**COMMISSION FOR
HISTORICAL & ARCHITECTURAL
PRESERVATION**

STAFF REPORT

REQUEST: Consent Agenda – Remove unapproved work; reconstruct original third floor; add deck to roof of reconstructed two-story addition

ADDRESS: 119 S. Gilmore Street (Union Square Historic District)

Image 9: Previous and proposed rear elevation, 119 S. Gilmor Street, April 5, 2018

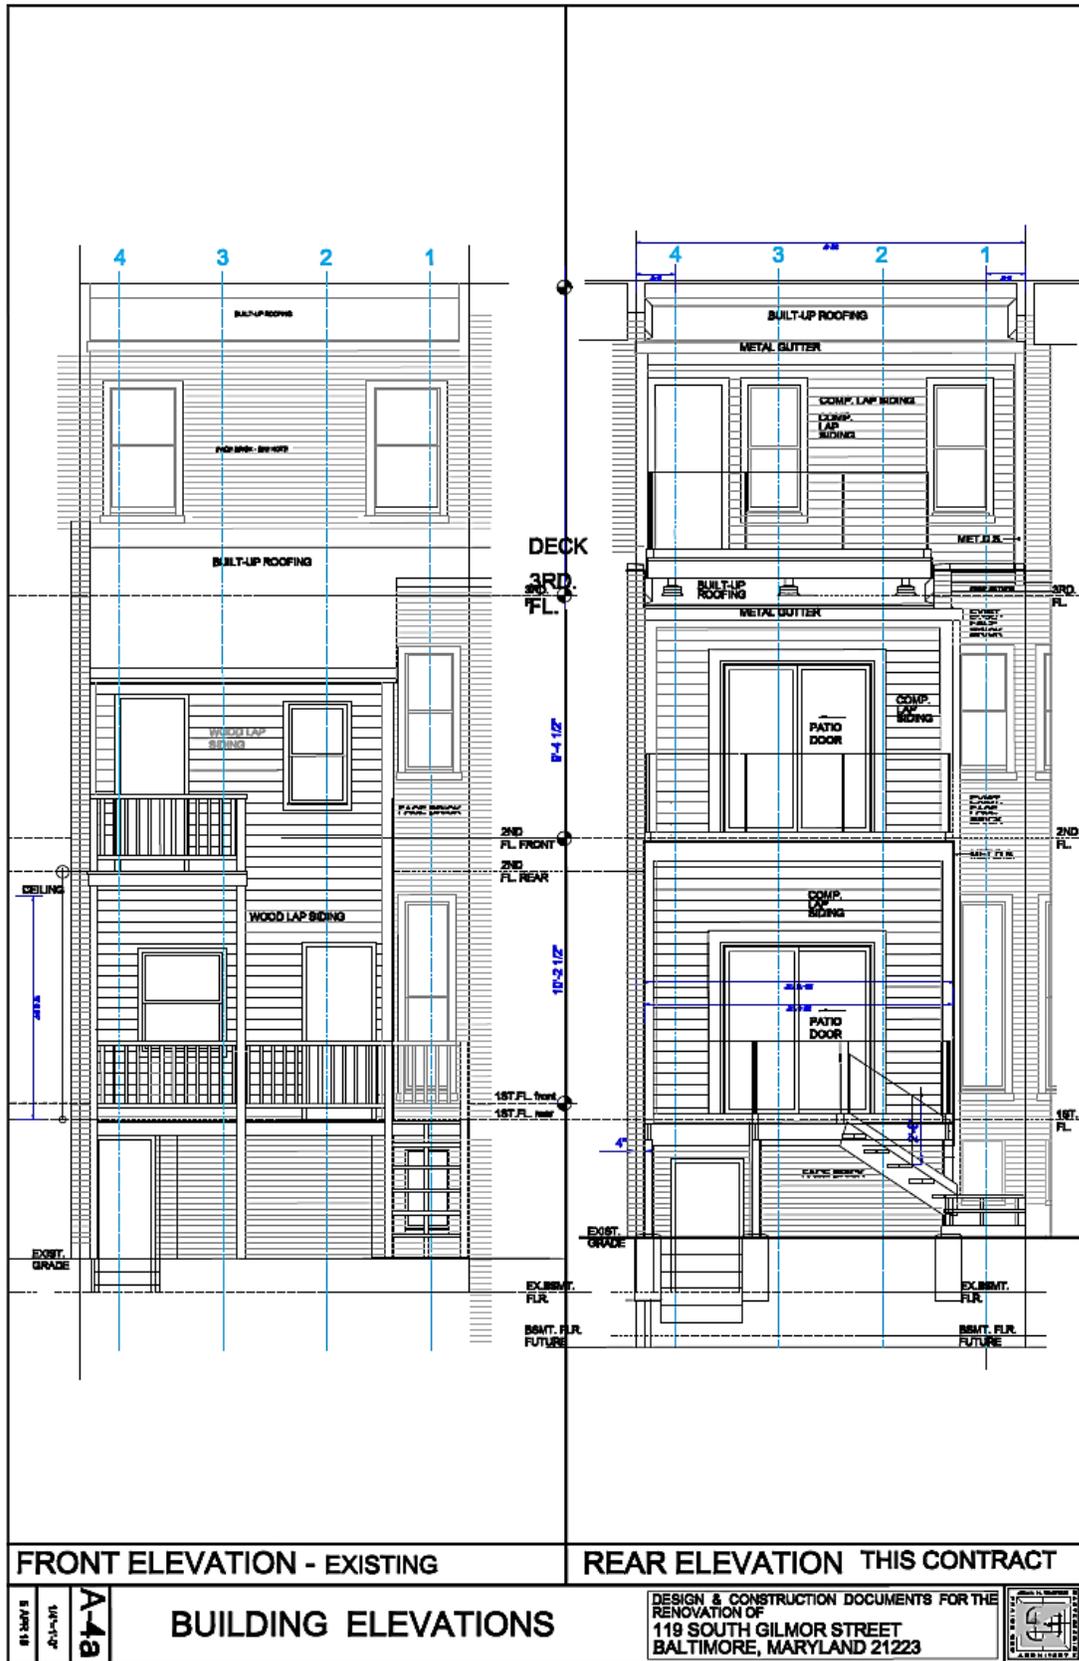
- *Guideline 2.5.1. Doors and Windows:* The windows and door at the proposed rear elevation are different from that of the previous elevation. In addition sliding glass doors are introduced at the first and second floors, where French doors would be more appropriate. Because this is the rear elevation, the design guidelines are partially met.

- *Guideline 2.5.2 Materials:* The proposed exterior finish for the addition at the rear is cementitious lap siding which is compatible with the surrounding properties and therefore meets the guideline.

Image 10: W. Pratt Street (south) elevation and rooftop deck plan, 119 S. Gilmore Street, March 25, 2018

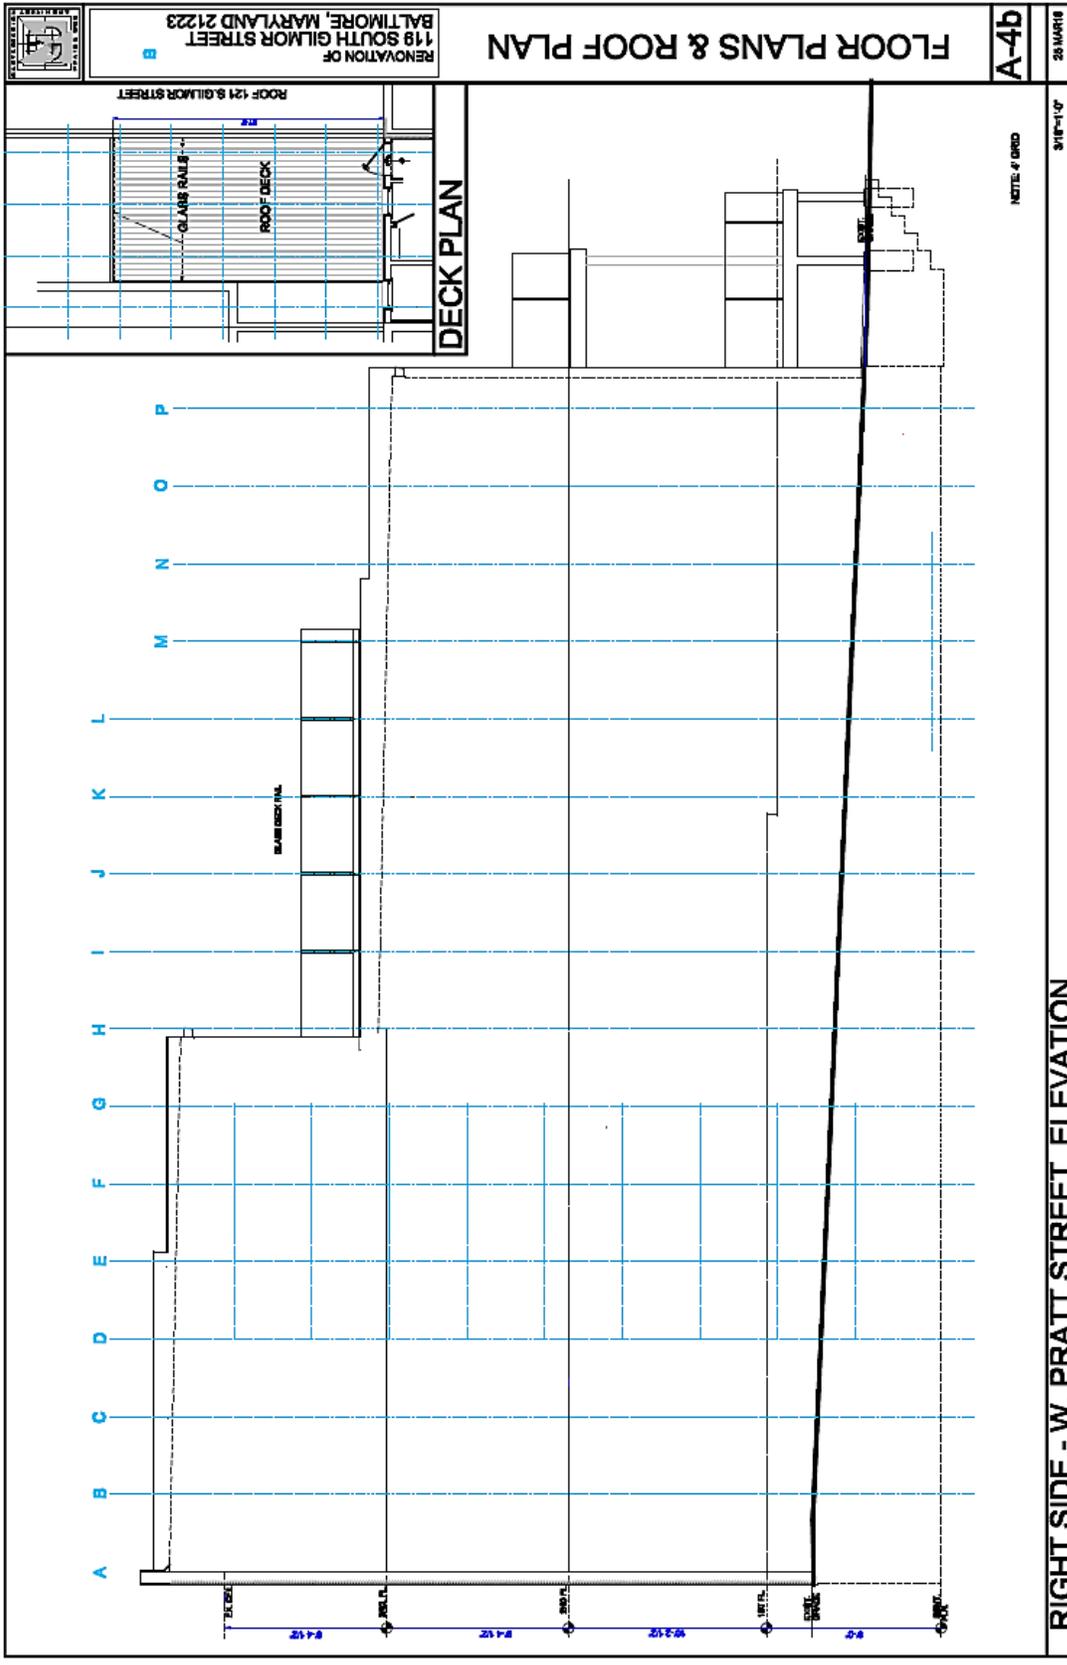
- *Guideline 1.8.10 Roof Decks:* The deck will not be visible from the front elevation. The roof deck atop the second floor will extend about 20 feet and be set back about 14 feet from the rear of the two-story building. It will be enclosed by a glass rail, making it only slightly visible, so it substantially meets the design guideline.

Staff recommends approval of the plan with rooftop deck details to be approved by staff.
